City of Surrey
PLANNING & DEVELOPMENT REPORT

File: 7911-0154-00

Planning Report Date: October 3, 2011

In order to permit the development of a 4-storey mixed use office/retail building.

Floor Plan Level 1 / P1

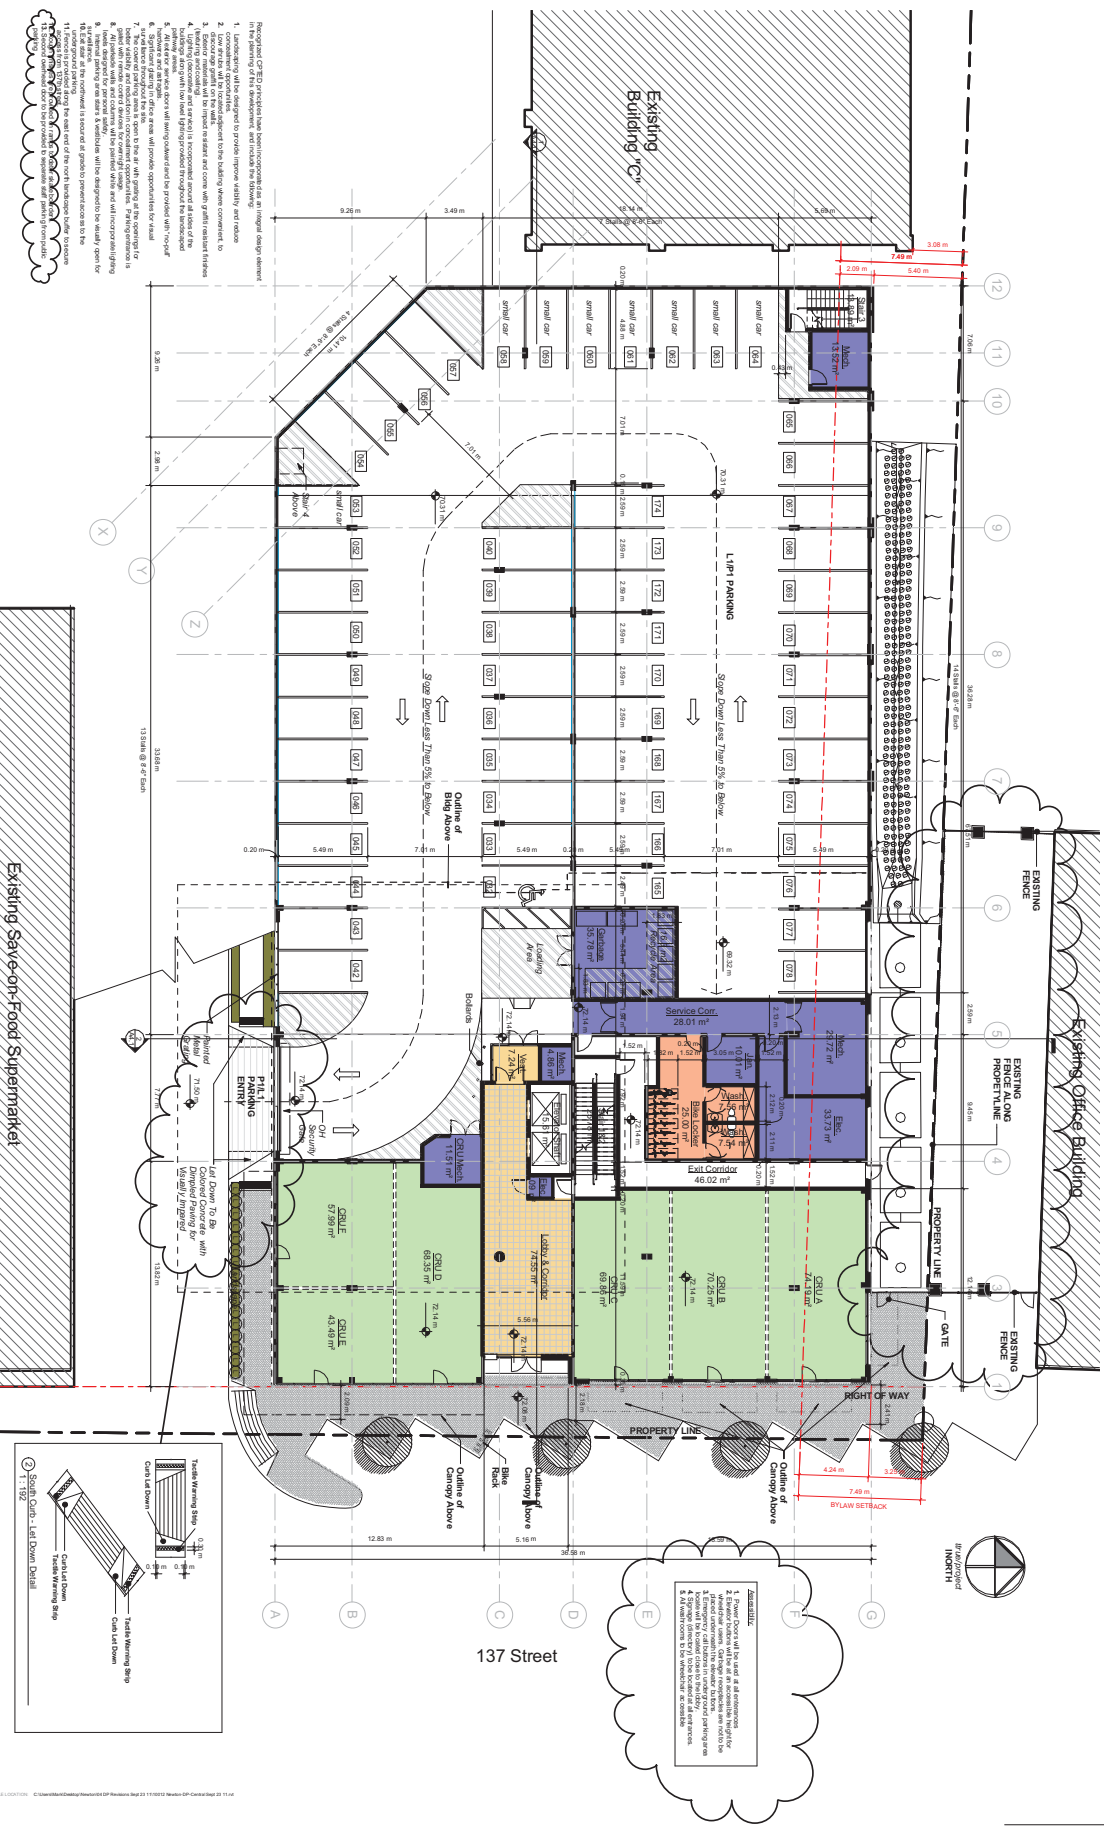
- a) **Main building entry – is very shallow; recommend recessing and glazing the entry to make the space less constrained, and/or deleting one parking space to provide a more defined entry at the street.**

- c) **Door from the loading to the elevator vestibule needs to be wider to allow for move in and large deliveries, e.g., double door.**
Agreed. Double glazed doors are now indicated. See drawing A2.2.

- e) **Entry ramp – turn at the entry is very close to the lobby vestibule – recommend setting the vestibule back, providing a curb and /or bollard to protect the vestibule.**
Agreed. Parkade entry turn is revised to be shallower and is set further away from the entry lobby. Bollards have also been introduced. See drawing A2.2.

- h) **Level P-1 - Provide landing in front of the elevator vestibule, separate from the loading.**
Done. See item e) above and Drawing A2.2.
- i) **Column is located in the middle of the loading area; does not appear to be aligned with the structural grid.**
Agreed. The column has been removed. See drawing A2.2.

We have further recessed the glazed entry as suggested. See drawing A2.2.

Signage Plan
 DATE: June 28, 2011 (Revised September 27, 2011)
 PROJECT NO.: 40025244
 ISSUE FOR: Resubmitted for CP Application

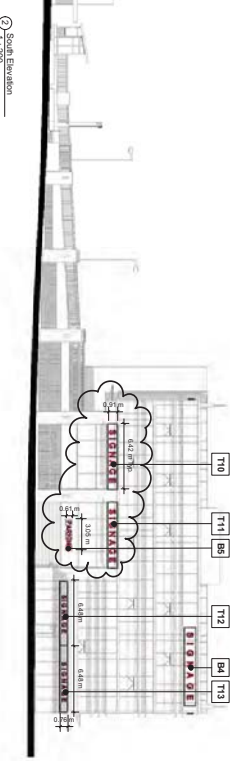
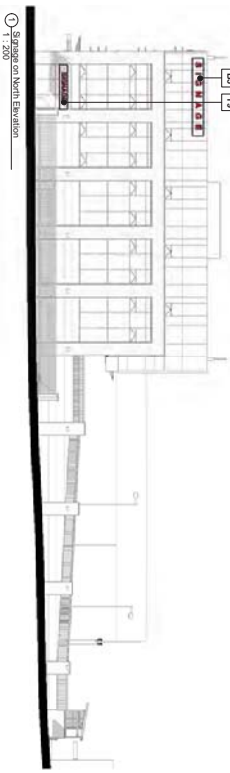
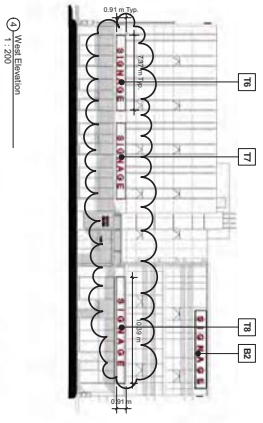
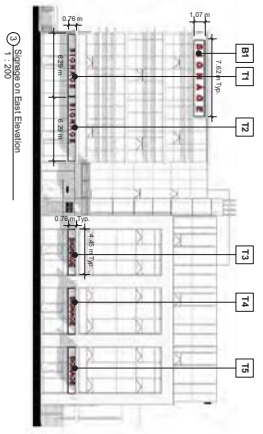
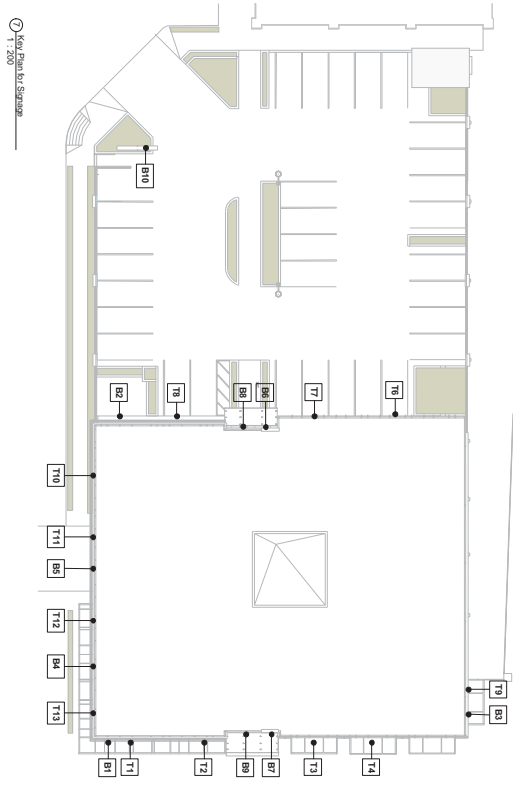
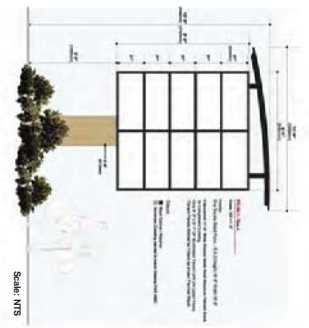
As discussed at our September 1st meeting, you requested that we revise our Signage Plan drawing to comply with imminent changes to the Signage By-Laws, along with other minor revisions and clarifications. We have done that as presented in drawing A5.1.

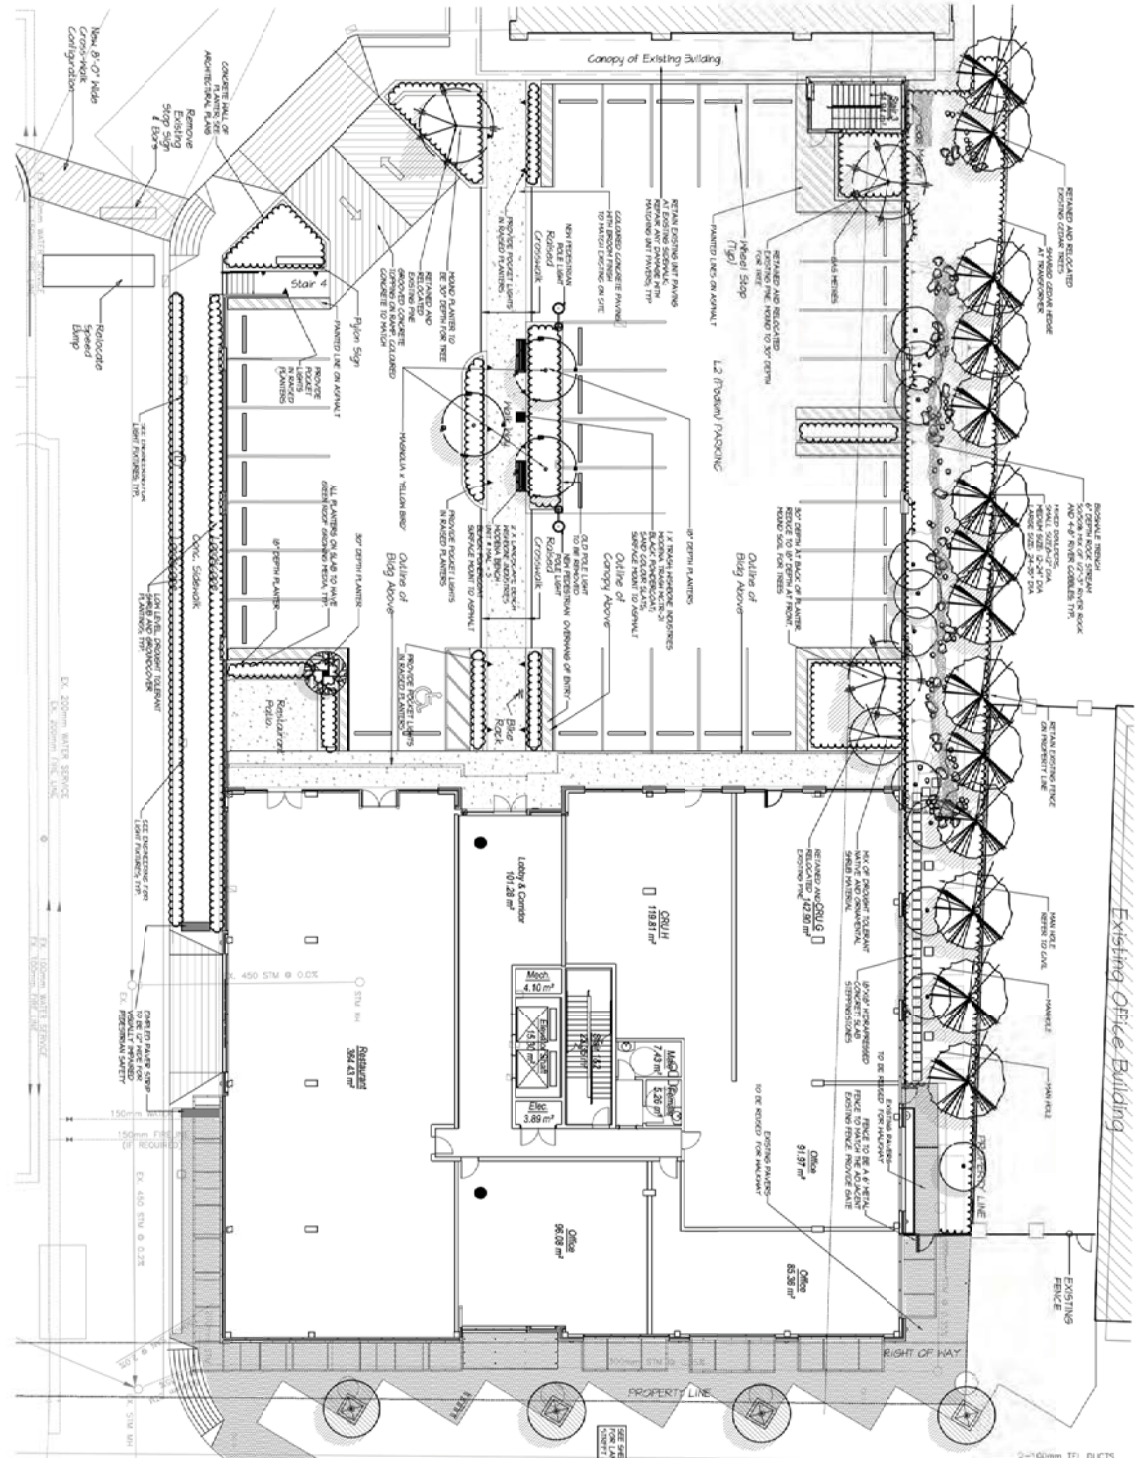
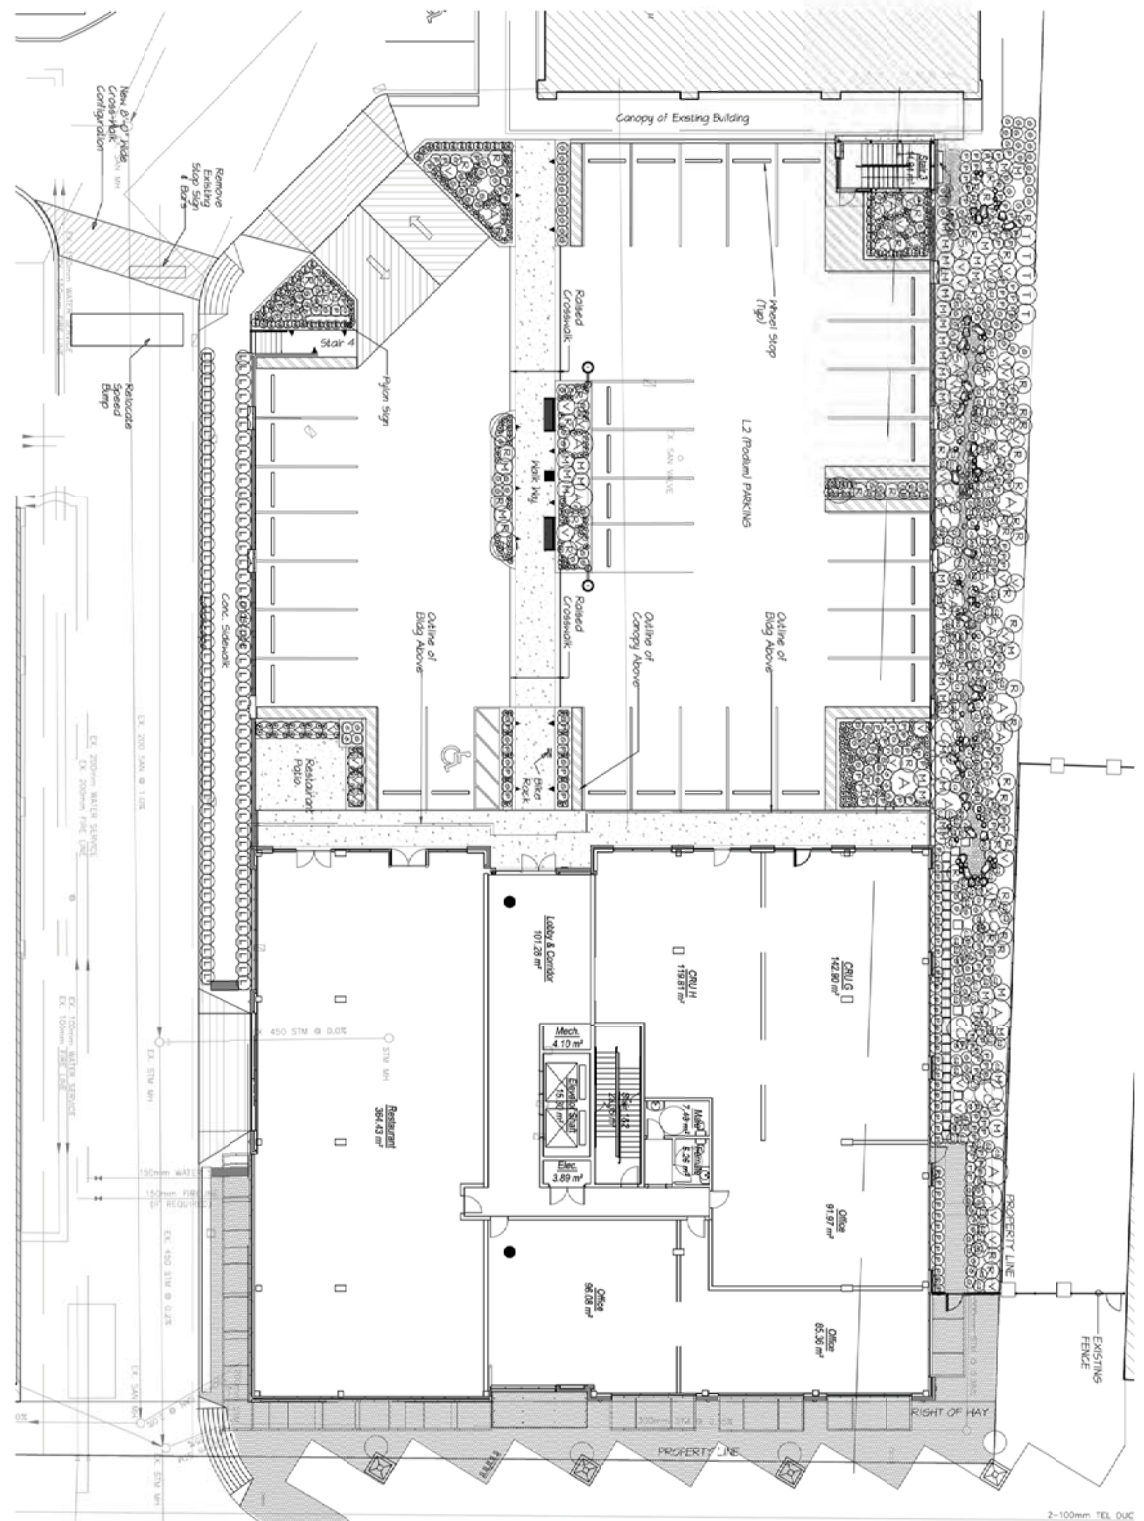
b) On the north elevation, the access to the north fire egress door should be left open with only low plantings. It should also be connected to the walkway.

c) Non friendly planting (e.g., thorns) is a good selection to keep undesirable people out of the area on the north side of the building. It is a good idea to keep people out of this area and keep view lines open for safety reasons.

Done. We have added a pathway from the exit door to the new paved area at the north-east corner of the building. See drawings L3 & L4.

Done. We have fenced off access to the northern landscaped area. Thorny planting has been indicated. See drawings L3 & L4.

NORTH ELEVATION: SCALE 1"=10'-0"

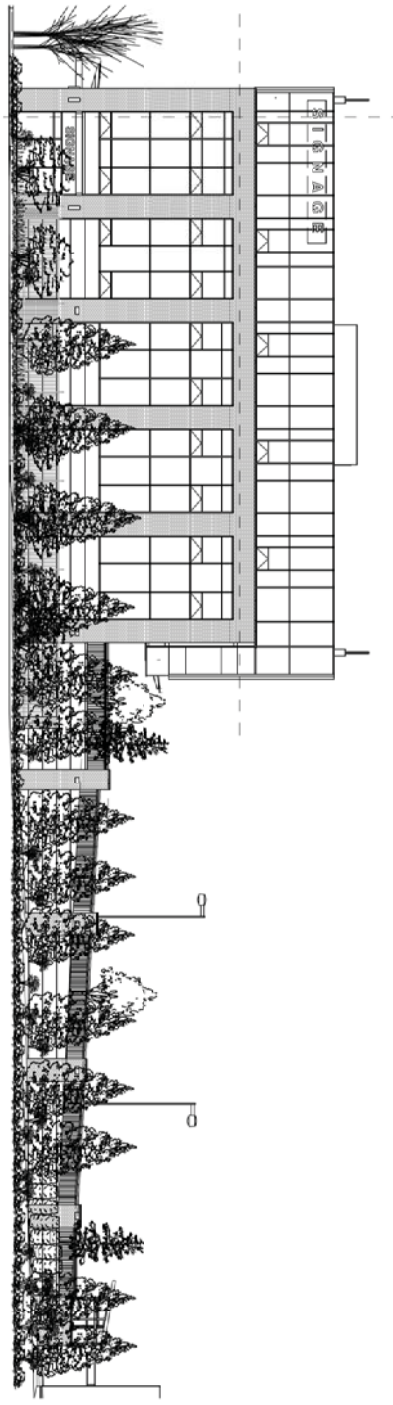
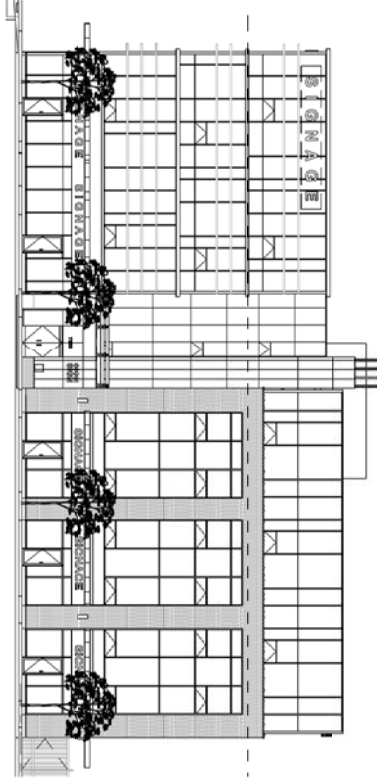
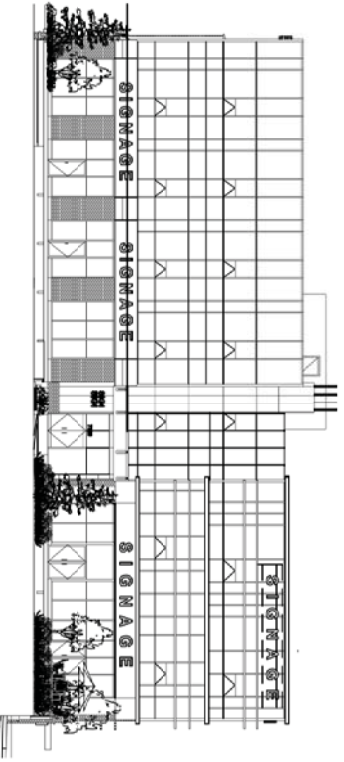
- g) **Building at the north is fully glazed above first floor. The proposed building has large areas of metal panel at the 2nd floor. Strongly recommend to replace metal panel with spandrel and to maximize the vision glass area at the 2nd floor.**
Done. The north façade has been revised to include additional spandrel glazing in place of metal panel. Additional vision glass cannot be accommodated due to Building Code limiting distance requirements along the north property line. See drawing A3.2.

g) The north elevation is not that appealing, especially if you are on the patio on the neighbouring property. Provide more friendly treatment towards adjacent building. If more glazing is not an option on the north elevation, given the limiting distance, consider using a more vibrant colour.

Done. We have reduced the extent of the metal panel and replaced it with spandrel glazing to match the glazing already in place. See drawing A3.2.
